THE MARYLAND-NATIONAL CAPITAL PARK AND PLANNING COMMISSION
Office of the Chairman, Montgomery County Planning Board

MEMORANDUM

REVIEW TYPE: Preliminary Plan Review

PROJECT NAME: Rock Creek Woods

ROCK CREEK WOODS PRELIMINARY PLAN

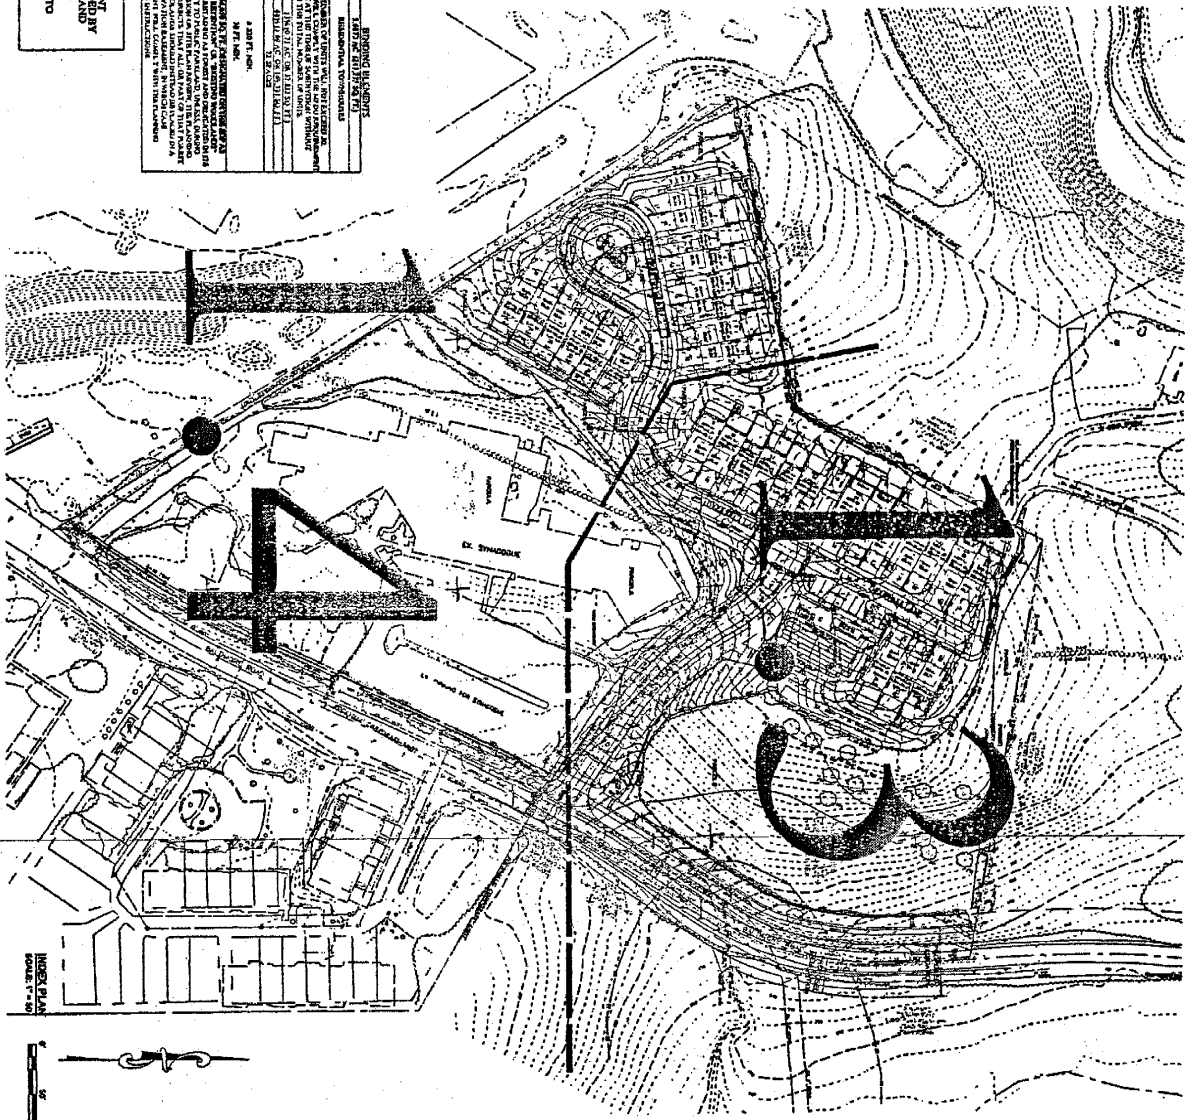
This is a preliminary plan application to create thirty residential lots and three recorded parcels; one parcel for the existing synagogue and the others for the townhouse open space and stormwater management (Attachment 2). The townhouse subdivision will access Baltimore Road via a private street system. The private street system will be designed to tertiary street standards, with 20 foot wide drive aisles to accommodate two-way traffic. If on-street parking is anticipated, the private street will need to be widened to 28 feet as part of the site plan, which will allow parking on one side only. A public access easement on all private streets will be reflected on the record plat(s) for the development. Fire and Rescue has reviewed and approved the private street access for conformance to their requirements.

STAFF RECOMMENDATION: Approval, pursuant to Chapter 50 of the Montgomery County Subdivision Regulations, and subject to the following conditions:

- 1) Approval under this preliminary plan is limited to a maximum of 30 one-family attached units, including four (12.5%) moderately priced dwelling units.
